CALIFORNIA COASTAL COMMISSION

5-20-0656 (NANETTE REED) DECEMBER 13, 2021

CORRESPONDENCE

408 Sherman Canal, Venice, CA (APN:4227015022) Application No. 5-20-0656 W15D Hearing Date: 12/15/21 Staff: C. Seifert-LB Applicant: Eyal Avraham Barbara Paderni Home Owner :Nannette Reed

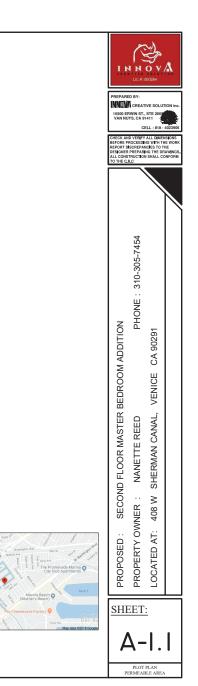
(Revise Design A-1.1)

Consent to this Condition. We are providing three parking spaces in the rear area, two are existing and the third will be parallel to the back alley for a compact car. (See revised plans for new parking dimensions and location)

The staff report is INCORRECT in citing that the Tufts Shed currently in backyard area requires a permit and therefore it is an unpermitted development. This is not a structure and pursuant to LADBS; a building permit is not required for "one-story detached accessory buildings used as tool and storage sheds, playhouses and similar uses, provided the floor area does not exceed 120 square feet" The current shed is 10'w x 8' d or a total of 80 sq ft. (see photo attached) so no permit is required and the shed will remain in the backyard as shown on Revised Design A-1.1)
